3773-001 TO FILE IN
(Takoma Park Historic District)

SUBJECT: Historic Area Work Permit

HISTORIC PRESERVATION COMMISSION STAFF REPORT

PROPOSAL: Construct one-story rear addition and deck

DOOR
PROPOSED
FOR
REPAIR

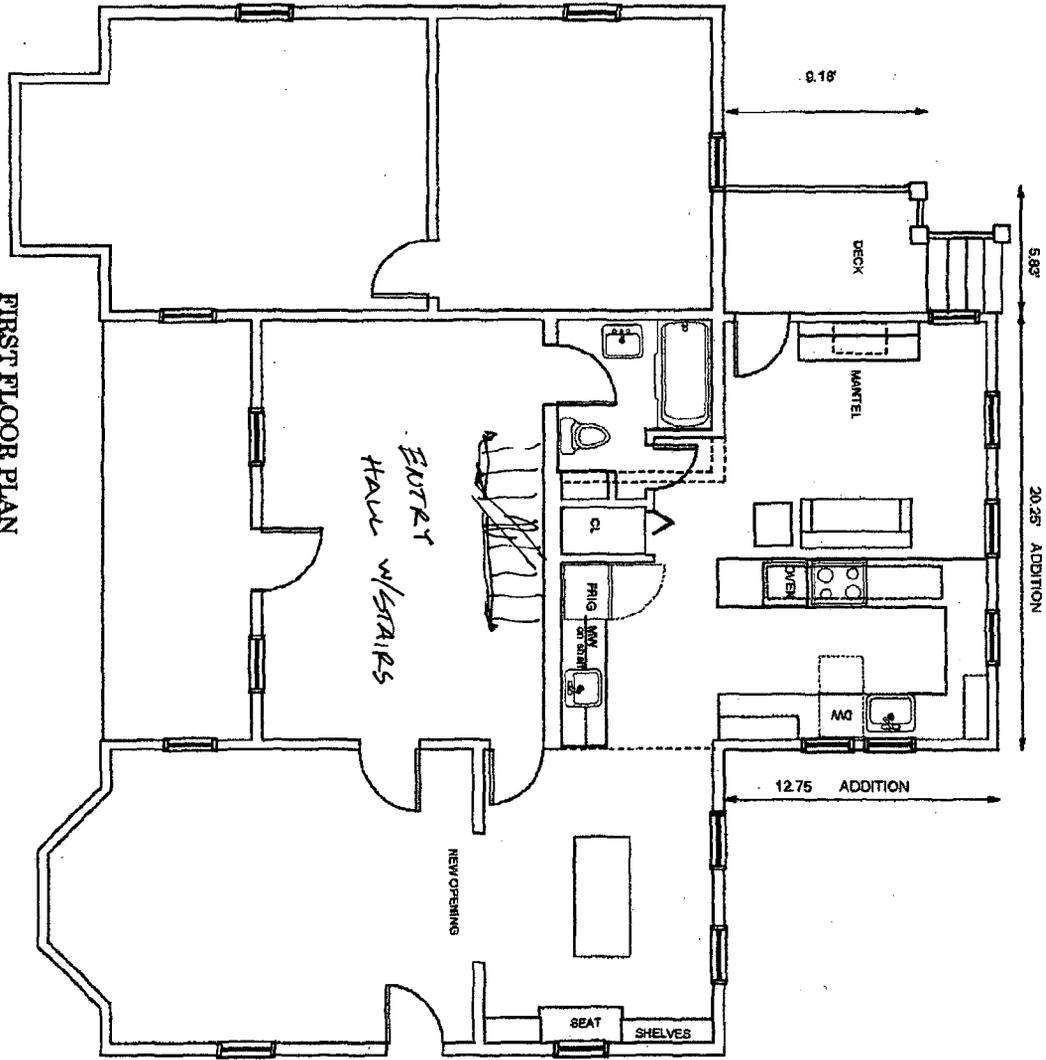
Staff notes that the two doors at the side porch appear to be original features. Both doors have been modified to accommodate storm doors at some time in the past. In addition, the doorway which is proposed to be removed has two additional pieces of shaped trim towards the base of the door, and the siding is neatly cut around this trim. This is the only doorway with this detail, and this would be lost with the removal of the doorway, especially as the siding would have to be pieced in below the new window, resulting in a small square of siding or require the removal of some of the original siding to effectively piece in the small section of new siding.

1. The existing side porch door will be retained in its present location.
2. The new north side door will be a wood paneled door, to be approved by staff.

SOUTH ELEVATION

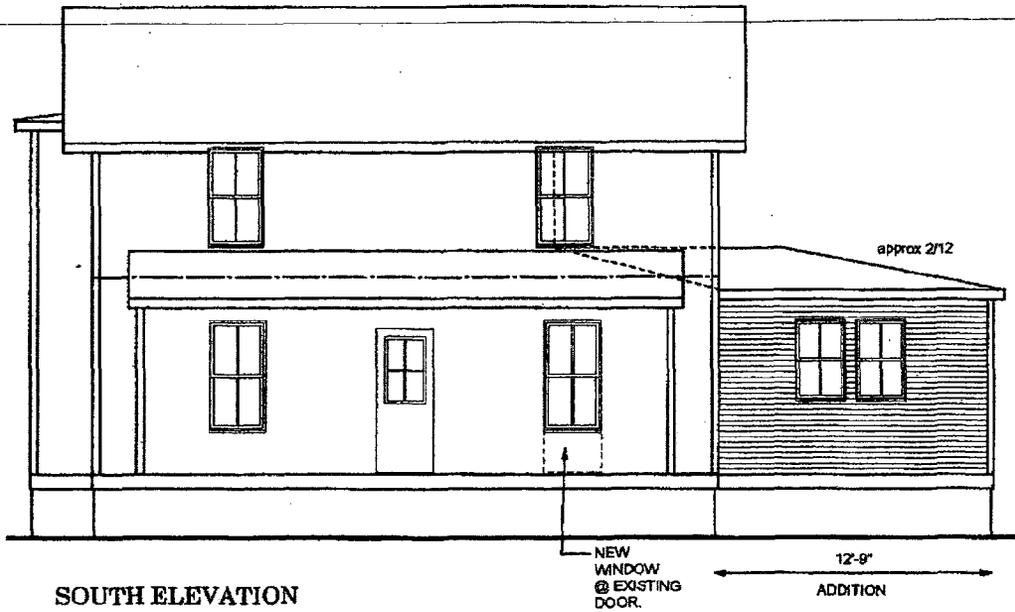
Programmatically, the applicant could effectively close off this opening with interior alterations and exterior furnishing in front of the opening even if the doorway is retained. The existing door is a wood paneled door that matches the other porch door, and there is a half-light to provide interior light. The Takoma Park *Guidelines* note that, for Outstanding Resources, "preservation of original windows and doors, particularly those with specific architectural importance, and of original size and shape of openings is encouraged." While this is a secondary elevation, this corner house has two street-facing elevations. The side porch facing Montgomery Avenue is a prominent element on the house, and the two existing doors indicate different interior spaces and an earlier need for access.

Approved as submitted
Revise based on new information from applicant:
2nd Down low window + vertical element is found on all the windows - probably for shutter - days.

1. ~~The existing side porch door will be retained in its present location.~~
2. ~~The new north side door will be a wood paneled door, to be approved by staff.~~
